# Mystery #5 of Interpolation Method(IPM)

### Mystery #5 ; Huge Error when adjust $f_{1,L}$ to $f_{1,H}$

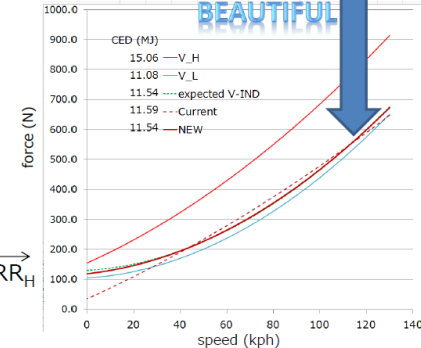
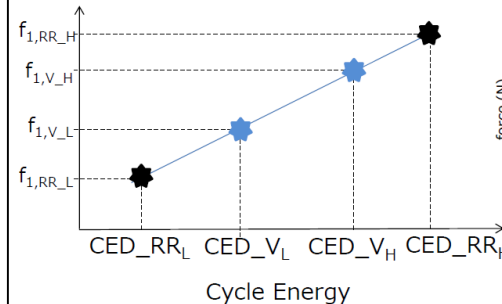
However, cycle energy demand is almost identical to original one  
→ calculated individual vehicle CO<sub>2</sub> is OK. BUT ....

IPM procedure has a possibility to derive unrepresentative road load curve profile which may cause unrepresentative test results.

$$f_{1,V_H \text{ or } L} = \frac{(CED_{V_H \text{ or } L} - CED_{RR_L}) * f_{1,RR_H} + (CED_{RR_H} - CED_{V_H \text{ or } L}) * f_{1,RR_L}}{(CED_{RR_H} - CED_{RR_L})}$$
